**REVISION 003 TO AN
INVITATION TO TENDER**

Title: Rehabilitation of Spillway 2, Canal Lachine National Historic Site	
Solicitation No.: 5P201-20-0086/A	Date: December 24, 2020
Amendment No.: 003	
Client Reference No.: 1452	
GETS Reference No.: PW-20-00930900

Amendment 003

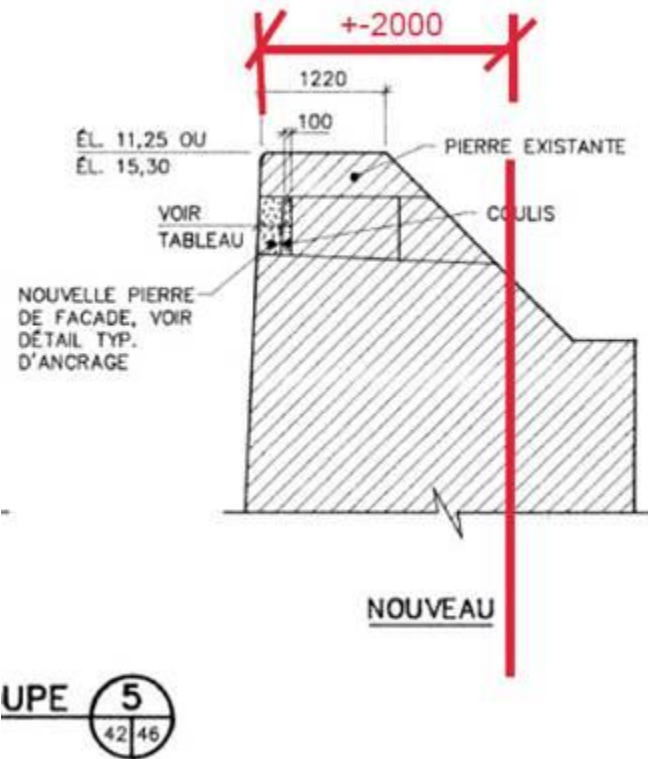
Q2 : Information on the wharf structure (wall behind which the injections are to be performed);

A2 : The existing drawings available do not clearly indicate the thickness of the canal walls and monolith. The outline shown on plan C5 shows only the top of the wall visible on the surface. As an indication, here is a section taken from the reference drawing GC-920-02-200-46-06.
